22-24 REDLON ROAD (PT LOT #9)

CITY OF PORTLAND, MAINE
Application for Permit to Install Wires

APPLICATION FOR PERMIT

Memorandum from Department of Building Inspection, Portland, Maine
22 Redlon Road- Construction of outside chimney

Sketch plan showing proposed changes in plumbing and the location of existing and proposed meters. Show water flow through submeter to non-discharge equipment or location. (Use additional sheet of paper if necessary)

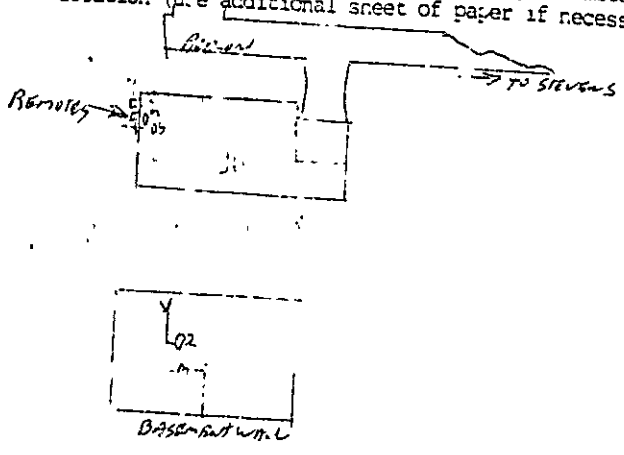
Description of proposed changes in plumbing required for sub-metering: ? CUT IN
SUBMETER ABOVE MAIN METER, RUN NEW SUPPLY LINE TO OUTSIDE
SILLCOCK

A WATER Back Flow Preventer or equal shall be installed. OUT SIDE SILLCOCK
